TOWN OF MILFORD, NH
OFFICE OF COMMUNITY DEVELOPMENT

Date: January 12, 2021
To: Planning Board
From: Lincoln Daley, Community Development Director
Subject: Zachary Clark (applicant/owner), Tax Map 47, Lot 39, 557 Route 13 South. Site Plan and Conditional Use Permit to construct a 1,300 square foot building to be used as a home industry based business within the Residential 'R' Zoning District.

SITE PLAN
TAX MAP 47 LOT 39
(557 ROUTE 13 SOUTH)
MILFORD, NEW HAMPSHIRE
 PREPARED FOR AND LAND OF:
ZACHARY CLARK
 577 ROUTE 13 SOUTH, MILFORD, NH 03055

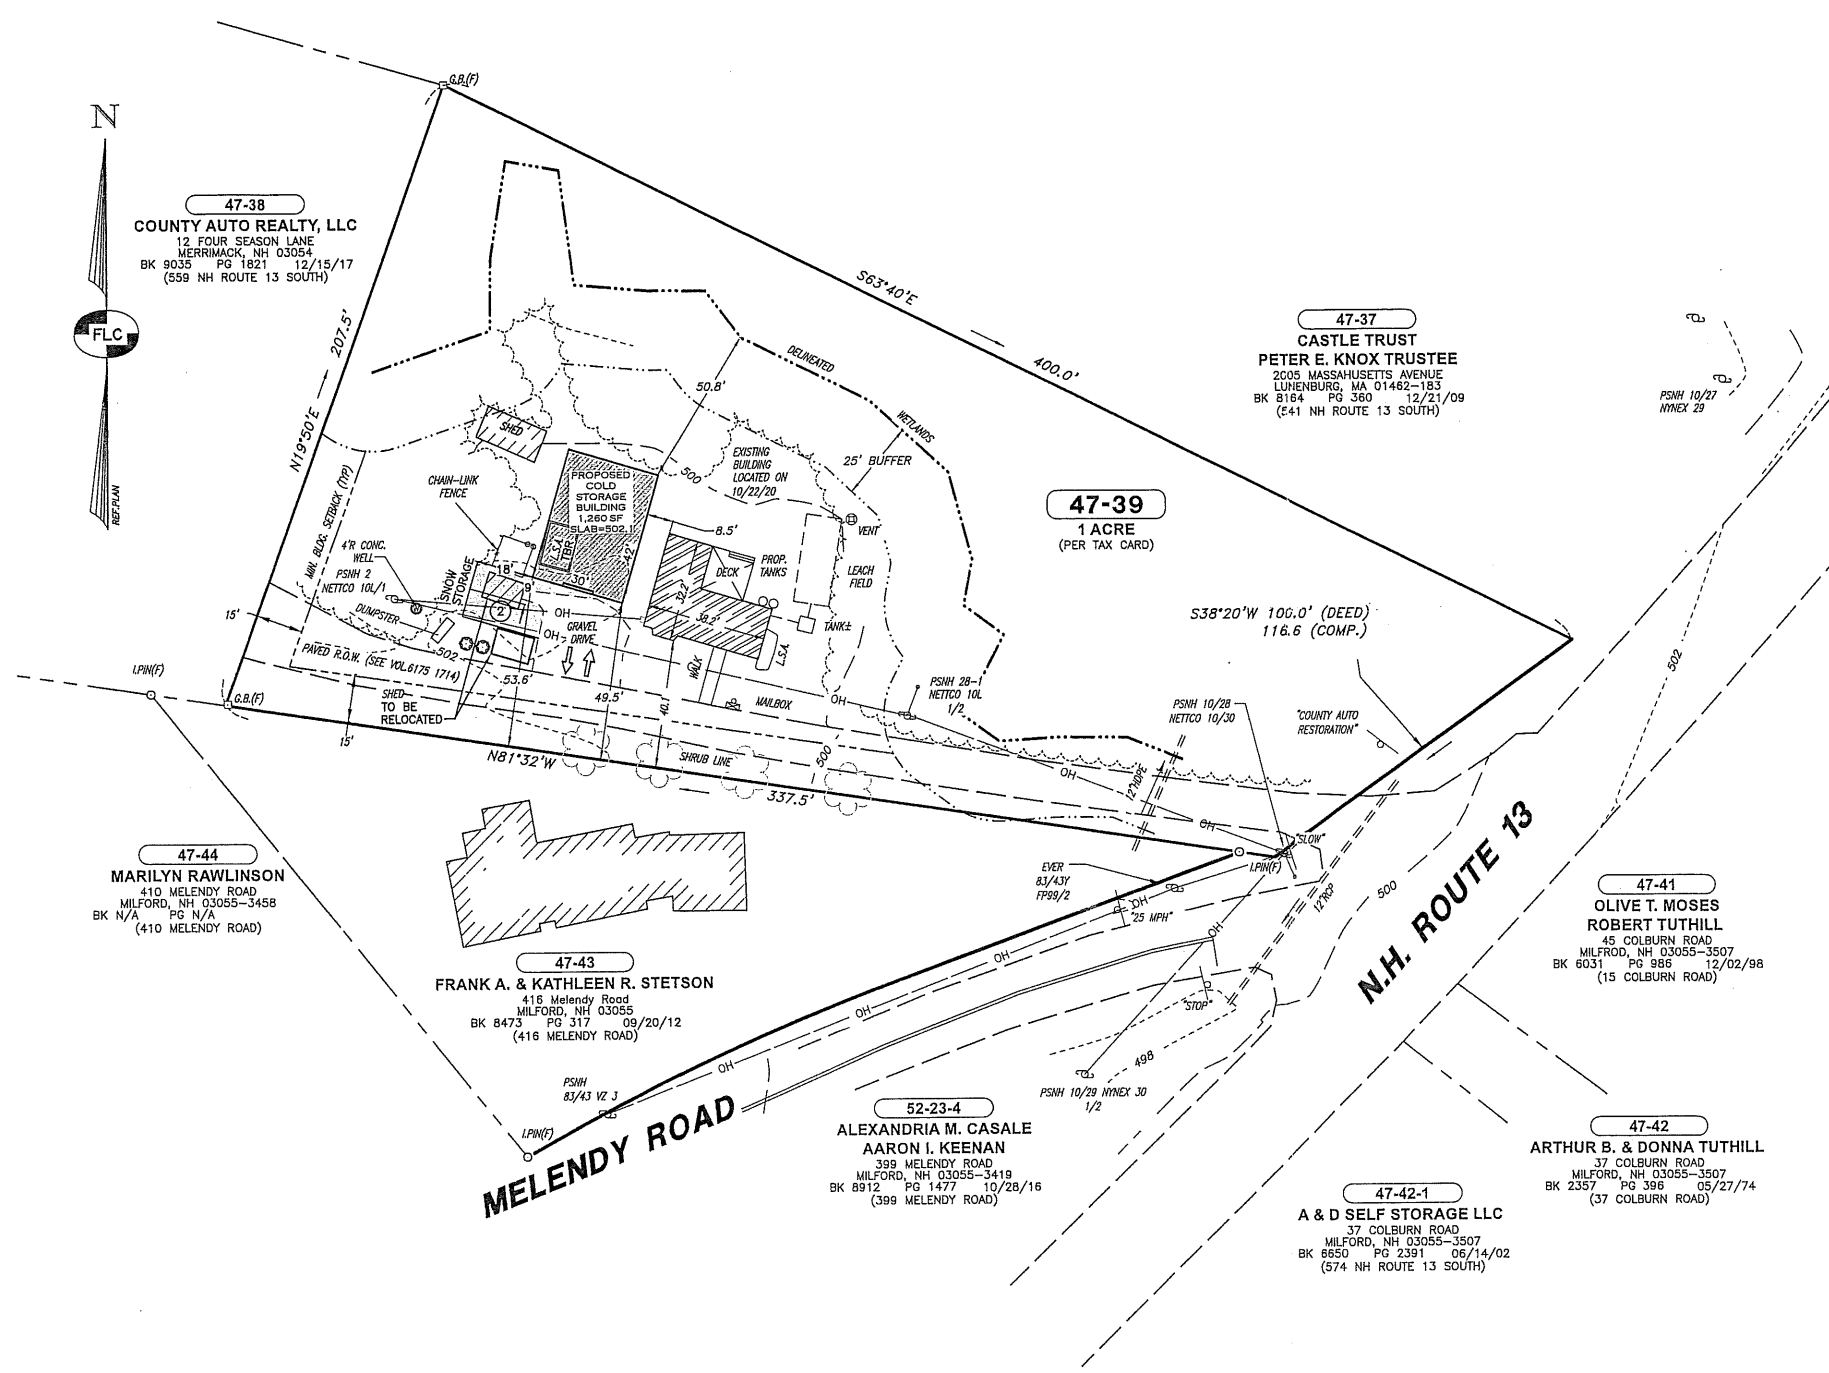
1. Proposed Note #1 – Please revise the note as follows, “The purpose of this plan is to depict a home based business (home industry) pursuant to Milford Zoning Ordinance, Article VII, Section 7.12 Home Based Business and the construction of a 1,260 SF proposed cold storage building and associated site improvements on the existing Tax Map Lot 47-39.

2. Insert Proposed Note #2 and renumber accordingly to read as follows, “The Home Industry use is subject the issuance of a Conditional Use Permit pursuant to Milford Zoning Ordinance, Article VII, Section 7.12 Home Based Business which was approved by the Planning Board on _____, 2021.”

3. The landscape plan indicates two additional plantings (inkberry holy bushes). Per Section 6.08.6 of the Milford Development Regulations, a minimum of one (1) shrub for every five (5’) feet of building frontage shall be provided. As such, the site plan requires a minimum of 6 shrubs. Given the location of the proposed building and proximity to the residential home directly across the private roadway, staff recommends additional plantings (year round) or fence to mitigate the visual impact of the building/use and spillage of lights from the company/employee vehicles leaving the subject property. The visual mitigation measures may be located on said abutting property with the permission of the owner. The plan should be revised accordingly.

4. Site Plan Legend – Please amend the label shown for the cold storage building to read “Proposed Cold Storage Building”. Similarly, please amend the label shown for the residence to read “Residence Building”.

5. Site Plan / Legend – Wall lights are shown in the Legend only. Please revise the plan showing all proposed lighting located on the proposed and existing structures.

6. Site Plan – Per Section 6.08.5 landscape buffers, the dumpster shown on the plan is require a buffers is required to provide a visual screen. Please revise the plan accordingly.

7. Site Plan – An existing shed is located in the wetland buffer. Either relocate the subject shed out of the wetland buffer or submit a Special Exception seeking relief from the Ordinance, Section 6.02.6.B to locate the structure within the wetland buffer.

8. Site Plan – Please amend the Planning Board Signature block by replacing “Subdivision” with “Site Plan”.
